SAFETY EVALUATION BY THE OFFICE OF NUCLEAR REACTOR REGULATION
RELATED TO AMENDMENT NO. 30 TO FACILITY OPERATING LICENSE NO. DPR-66

BEAVER VALLEY POWER STATION, UNIT NO. 1

DOCKET NO. 50-334

ATTACHMENT 1

Figure 1
Existing Steamline Break Protection System

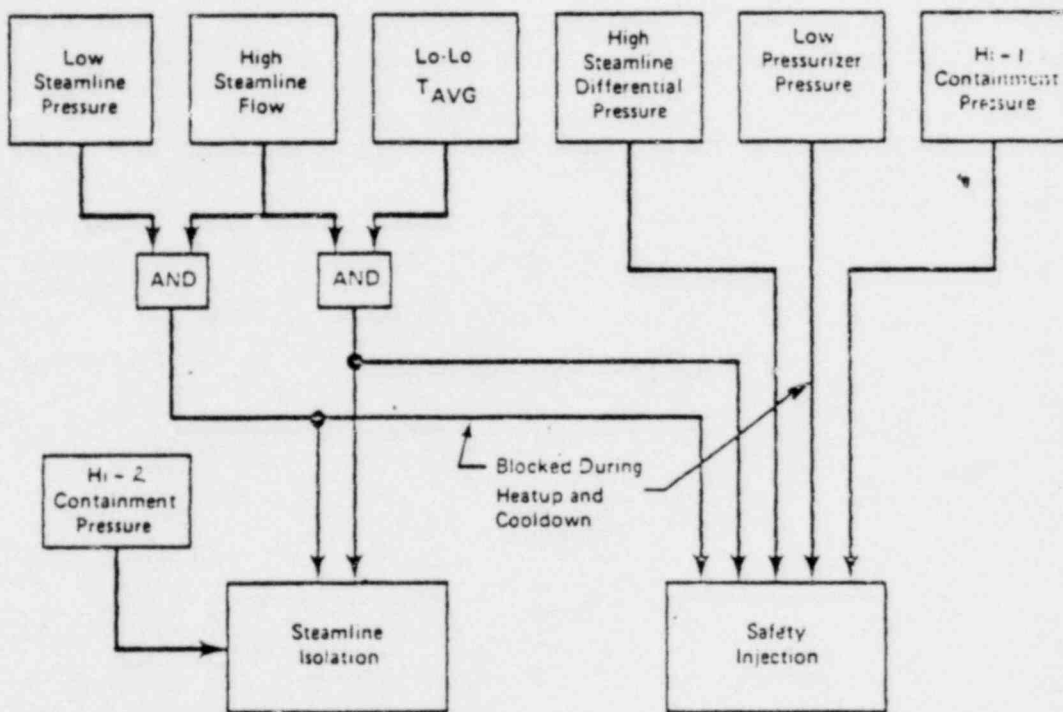
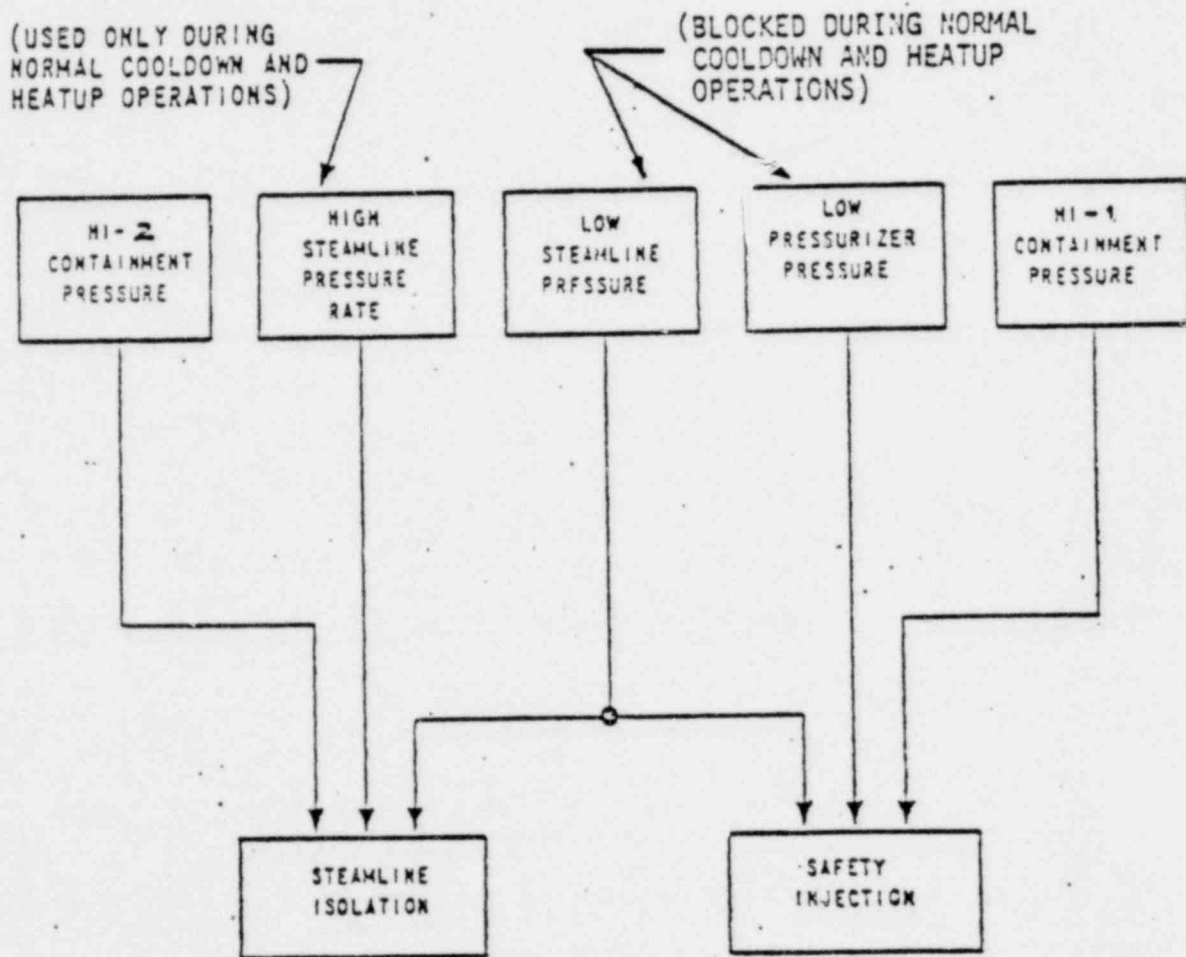
The existing and proposed BVPS SLBPSs consist of various detectors, electronics and logic arranged to provide two functions during SLB: 1) Actuation of the SI and 2) SLI. Figures 1 and 2 show block diagrams of the existing and proposed SLBPSs. Both figures represent only one of the two trains of actuation logic.

The proposed SLBPS has deleted the following SIS actuation signals:

- High differential pressure signals between steam lines.
- High steam line flow coincident with either low-low T_{AVE} or low steam line pressure.

The proposed SLBPS has added the following SIS actuation signals:

- Two-out-of-three low steam line pressure in any single steam line.

The proposed SLBPS has deleted the following SLI signals:

- High steam line flow coincident with either low-low RCS T_{AVE} or low steam line pressure.

And has modified the containment pressure trip setpoint from "high-high" to "intermediate-high."*

The proposed SLBPS has added the following SLI signal(s):

- Low steam line pressure (above P-11)
- High negative steam line pressure rate (below P-11).

The low steam line pressure logic circuitry in the existing SLBPS actuated if two-out-of-three steam lines had pressure below 500 psig.** However, the proposed SLBPS low steam line pressure logic employs "lead-lag" conditioning circuitry. The circuit takes the steam line pressure as an input and outputs a signal proportional to the derivative of the input, which decays to the value of the input at the time constant τ_z . Thus, the "lead-lag" signal conditioner results in a faster response to changing steam line pressure.

The high negative rate of change of steam line pressure function employs a "derivative-lag" signal compensation. This type of signal compensation is the same as that used in the T_{AVE} input to the overpower ΔT reactor trip setpoint calculator. The "derivative-lag" signal conditioner takes the input signal, steam line pressure, and outputs a signal representative of the lagged version of the derivative of the input. Thus, if a steam line break occurred below P-11, SLI would occur only if the break area was large enough so that the rate of change of steam line pressure resulted in a conditioned signal that exceeded the trip value. If the break area was below that "trip" area, then SLI would not occur

Based on the comparison of the trips and trip times afforded by the existing and proposed SLBPSs, and the trips assumed in the BVPS FSAR, the staff concludes that the new SLBPS affords acceptable protection for SLBs during normal plant operations (the plant is critical at any power level).

FIGURE 3 COMPARISON OF STEAMLINE BREAK PROTECTION SYSTEM RESPONSES

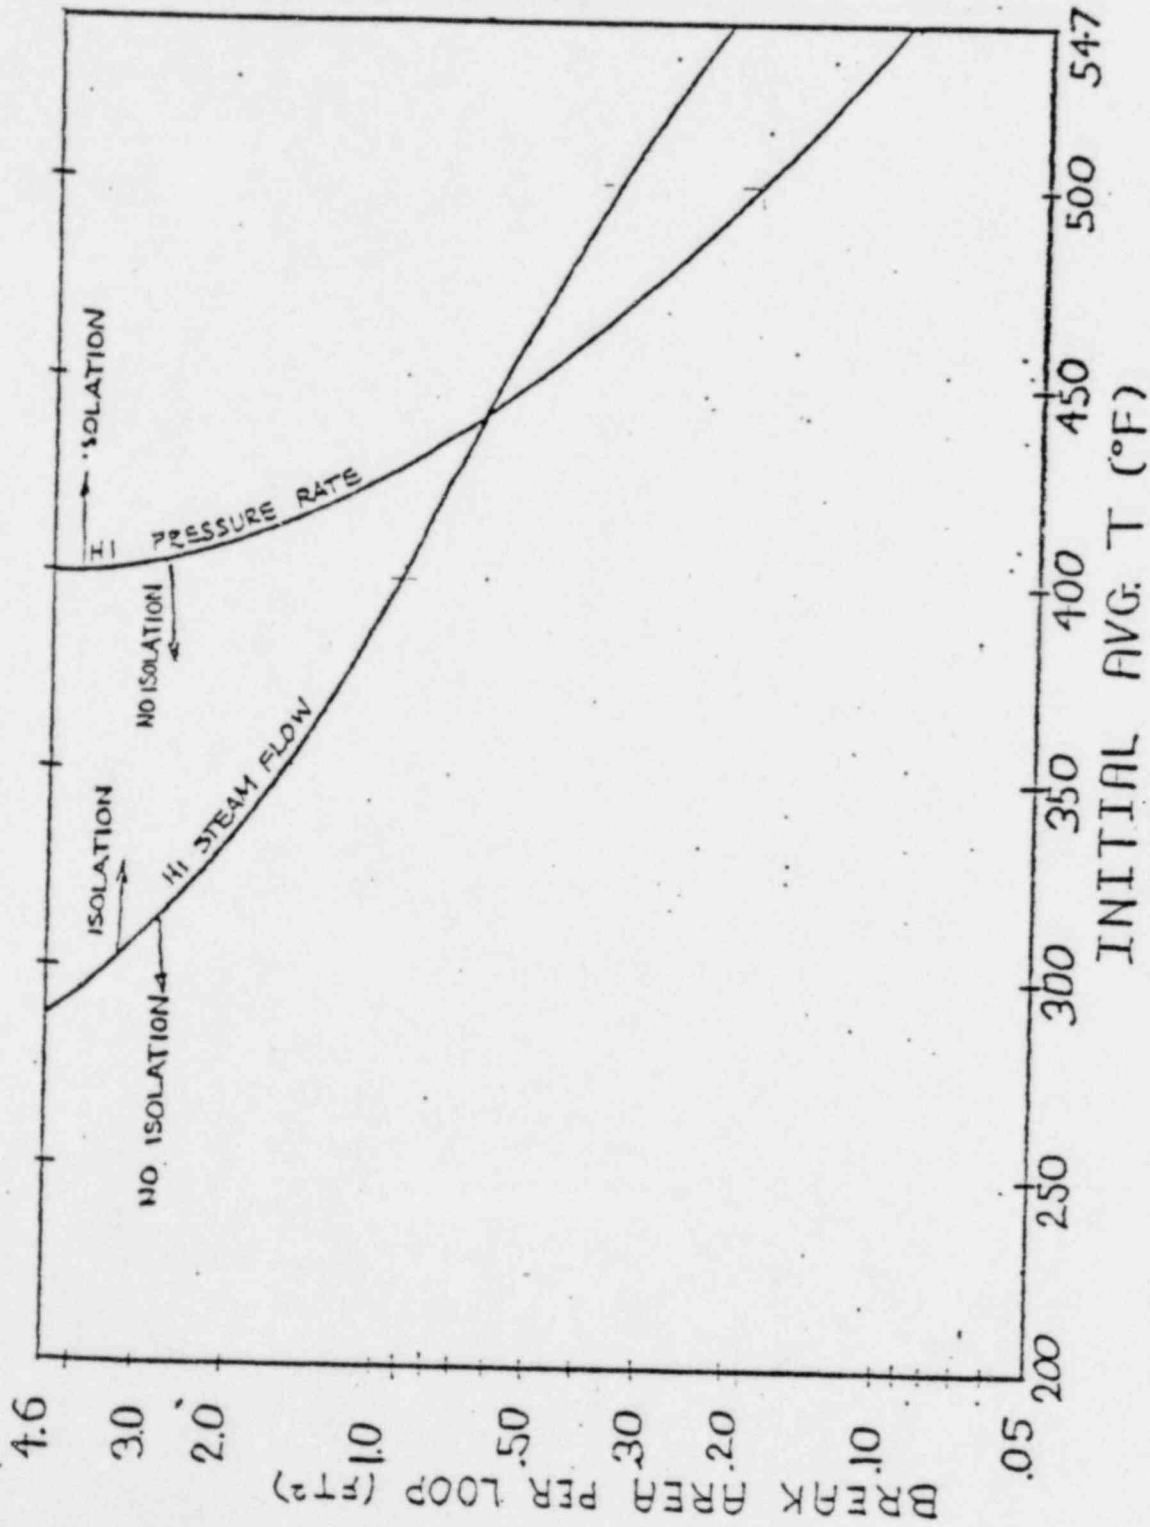
The staff also asked the licensee to compare the protection afforded by the existing and the proposed SLBPS for SLBs during heatup/cooldown.

The licensee, in Reference 5, provided Figure 3, below, which shows how the existing and proposed SLBPSs compare in providing protection for all SLBs downstream of the NRV (outside containment). The figure shows that SLI will occur for both systems if the break area is about 0.44 ft^2 and the initial RCS temperature is about 435°F . If RCS temperature is below 435°F , generally the existing SLBPS provides SLI for a larger spectrum of break areas than the proposed SLBPS.* If RCS temperature is above 435°F , the new SLBPS affords greater protection than the existing system.** Therefore, the existing SLBPS provides better system response to SLBs downstream of the MSIVs for temperature below 435°F , but the system response with the proposed SLBPS has been shown to be acceptable (i.e., adequate core cooling, acceptable offsite doses (no DNB occurs) and the system remains subcooled). Therefore, even though the proposed SLBPS affords less protection than the existing SLBPS (for certain initial RCS temperature), the results of a SLB with the proposed SLBPS are acceptable, and therefore the proposed SLBPS is acceptable for protection from SLBs during heatup and cooldown operation.

*For example if RCS temperature is 400°F , the existing system shuts the MSIVs for SLBs with area greater than about 0.90 ft^2 , whereas the proposed system will not shut the MSIVs, regardless of the break area.

**For example, if RCS temperature is 500°F , the existing system shuts the MSIVs for SLBs with area greater than 0.34 ft^2 , whereas the proposed system gives SLI for break areas greater than 0.18 ft^2 . Therefore, at the RCS temperature of 500°F , the new system provides protection for break areas 0.18 to 0.34 ft^2 , which the existing system does not.

With respect to SLBs during RCS cooldown and heatups, the staff concludes that the proposed SLBPS provides adequate protection, even though there may be a reduction in protection below that afforded by the present SLBPS. The licensee has demonstrated that even if the normal charging system were lost at the moment of the SLB which gives the "worst" system response, there is sufficient time and indications for the operator to regain normal charging, or establish charging via another path, before the RCS reaches a saturation condition. Therefore, the staff concludes that the proposed SLBPS affords acceptable protection for SLBs during RCS heatup and cooldowns. We also conclude that the proposed technical specifications regarding establishment of cold shutdown boron concentration prior to blocking the low Pp SI trip is necessary and acceptable.
